West Memorial Building Rehabilitation

To obtain Developed Design Approval for the proposed West Memorial Building Rehabilitation, at 344 Wellington Street, in Ottawa.

2018-P191 - West Memorial Building Rehabilitation (C)

## 7. Entrance Design: Terrace Scheme

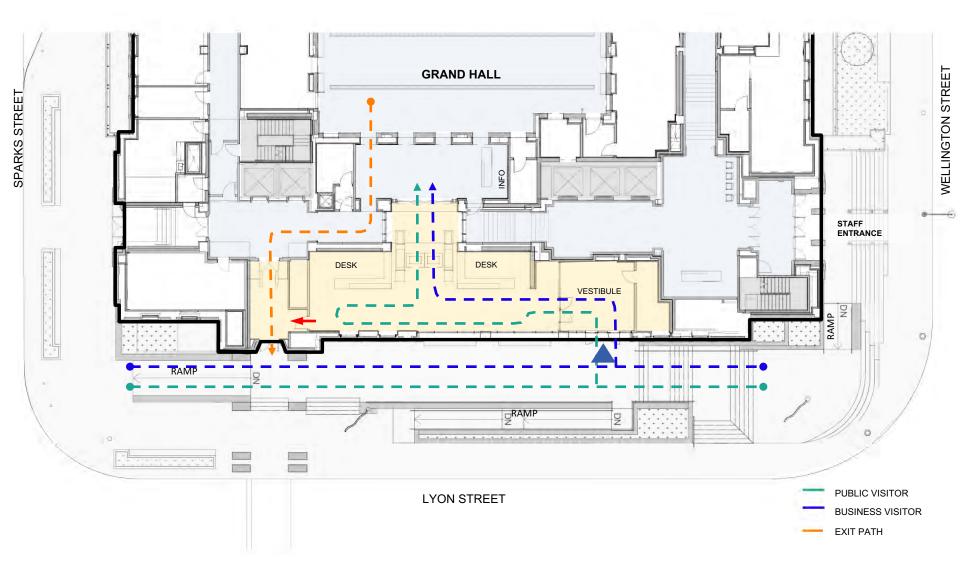
- The character and hierarchy of the new main entrance need to be enhanced.
- Architectural detailing could be added (to mimic what has been done inside for the entrance to the courts) in order to create a grand entrance. Stones that are removed should be numbered and put in storage.
- The staff entrance still feels like the main entrance and signage may not resolve the issue.
- More seating should be provided outside the new entrance, as well as shade for those waiting outside.
- Visitors could be guided across the street towards amenities in the current Supreme Court park.

An elegant ramp should be considered

instead of stairs.

The existing corner UA access to the staff entrance needs better integration with the new scheme.
